3078 SW AVALON WAY - WEST SEATTLE

Changes to the Approved Design due to FAR Adjustments

Clarification and Responses to the Hearing Examiner’s Decision:

Site Plan Showing Grading Adjustment Locations

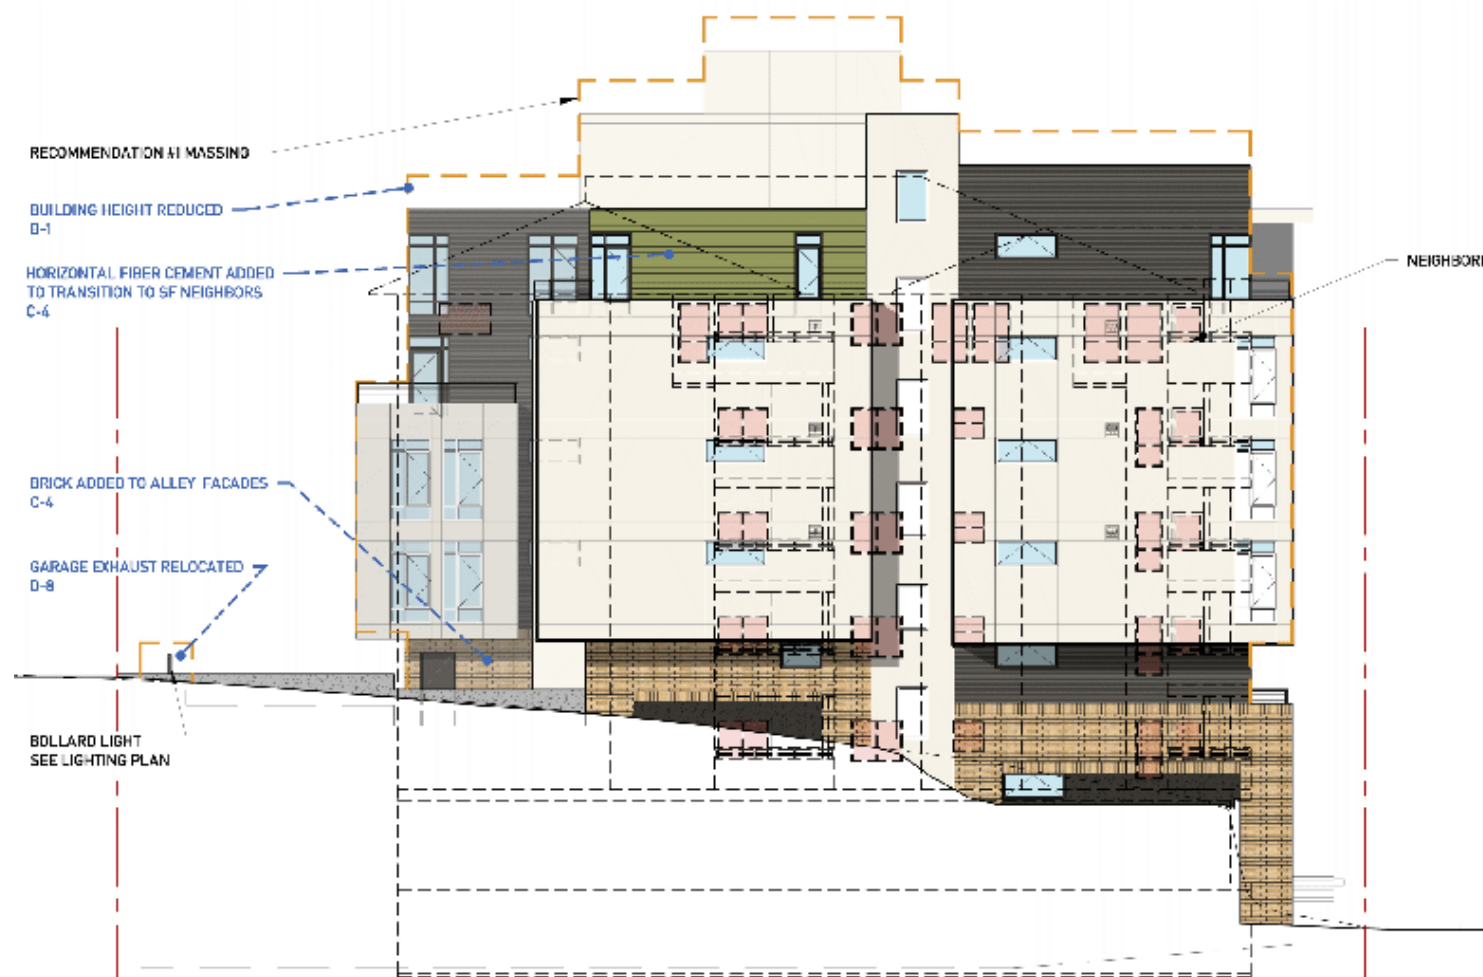
Changes in grading occur in only three locations. See corresponding clouded areas on this page for clarification of where grade adjustments occurred.

Grade Revision Area #1:
Raised and leveled grade along the southeast portion of the site. Board approved window was deleted by this change. See Page 5.

Grade Revision Area #2:
Raised grade along northeast portion of site approximately 18" (include three additional trees per previous Design Recommendation conditions of approval). Perceived height of retaining wall reduced. Board approved windows were affected by this change. See Page 6.

Revision Area #2

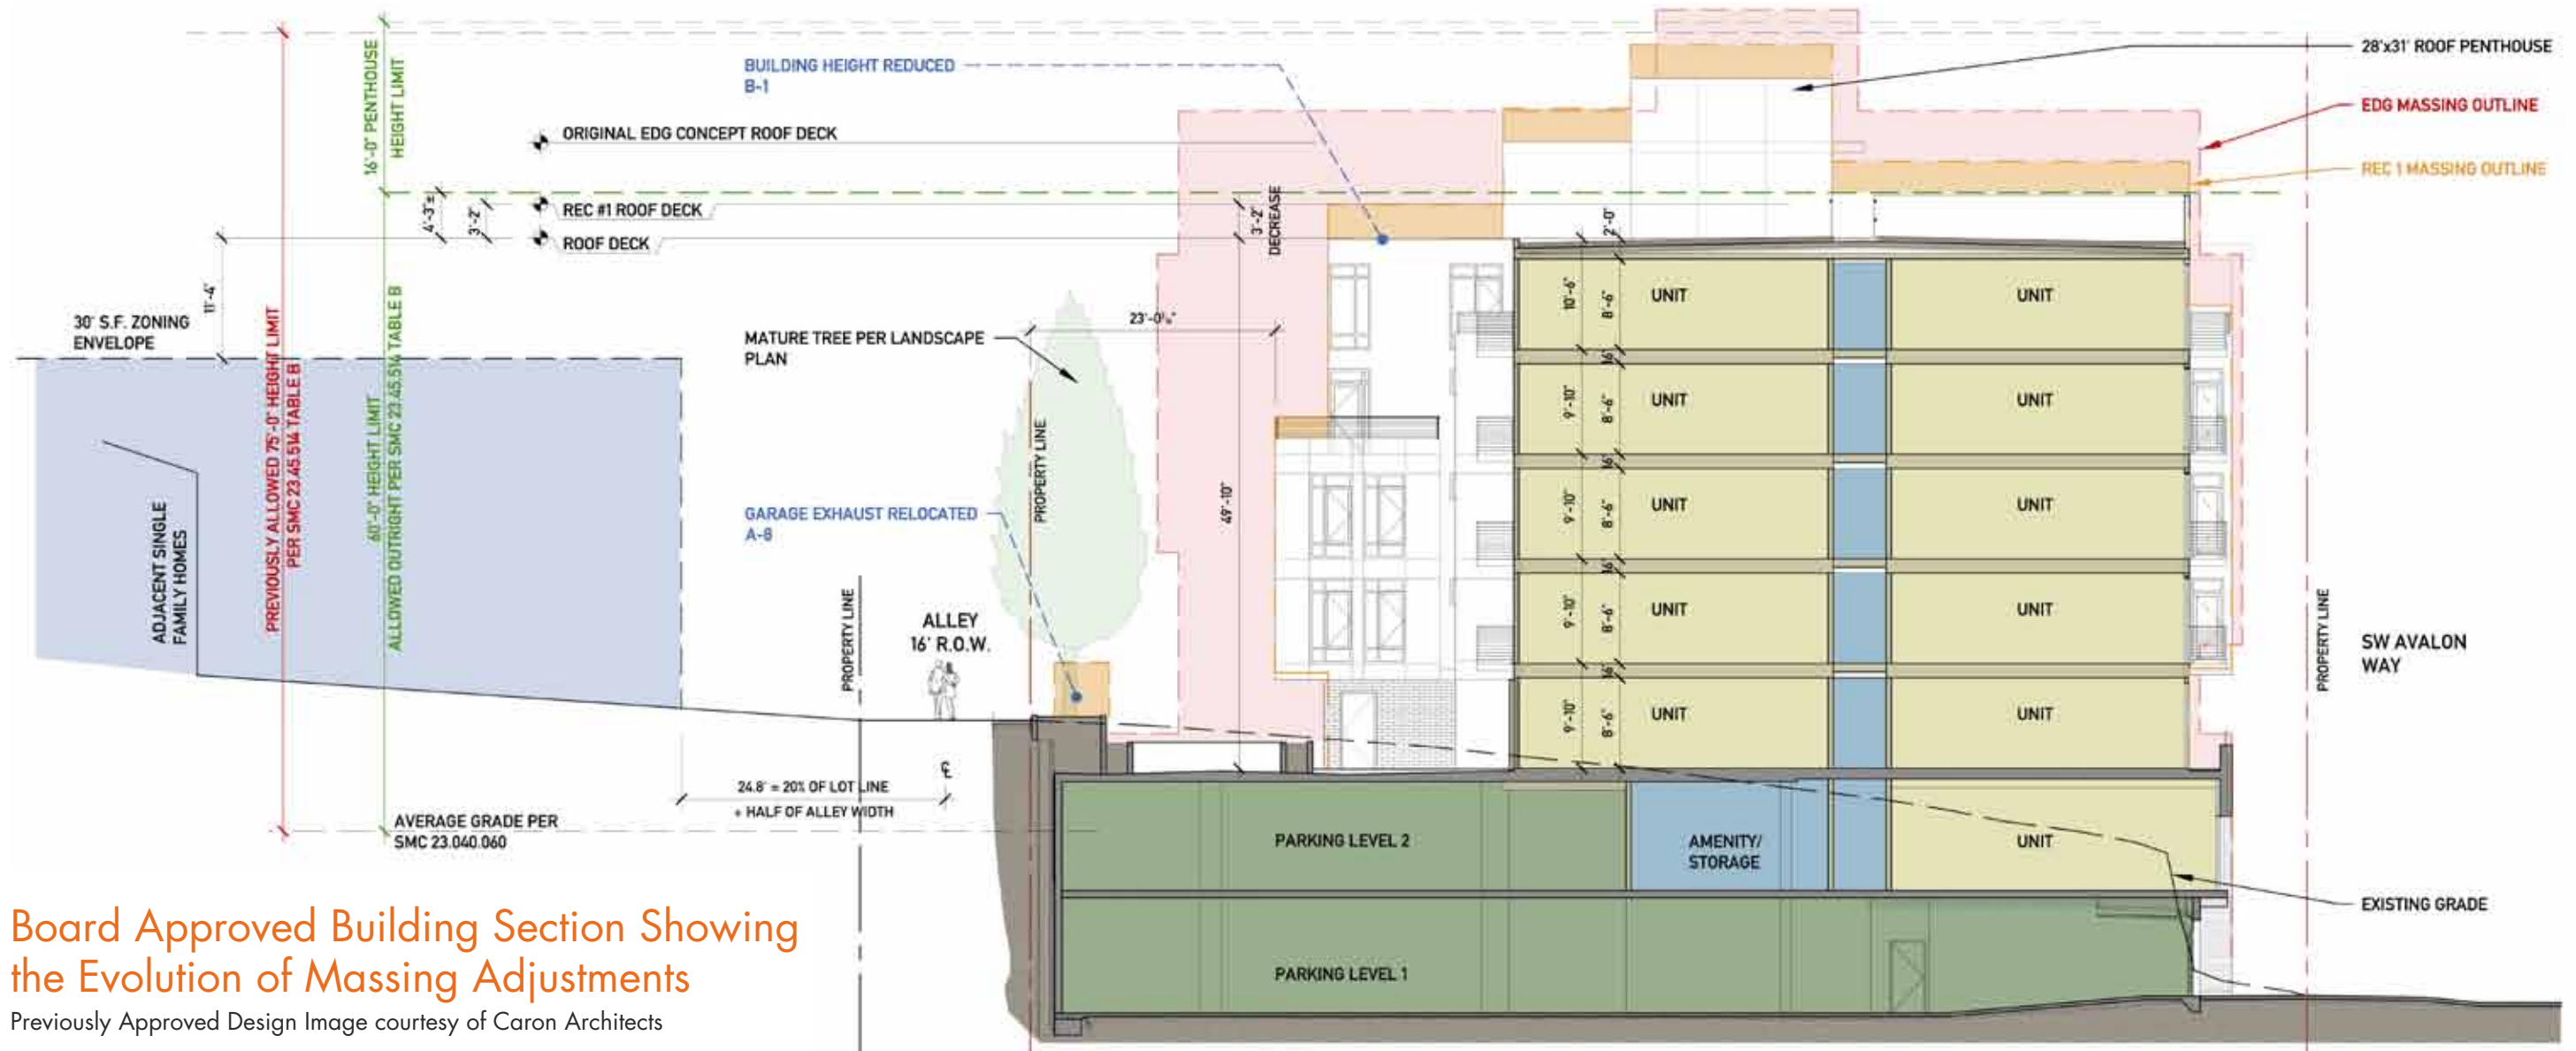
The clouded area in the image above shows the limited amount of design change due to the reduction in attributable FAR. Changes include raised grading at Level 2, reduced window sizes (approximately 18” less in height), and reduced perceived retaining wall height.

Raised grade along northeast portion of site approximately 18” (include three additional trees per previous Design Recommendation conditions of approval). Perceived height of retaining wall reduced. Board approved windows were affected by this change.
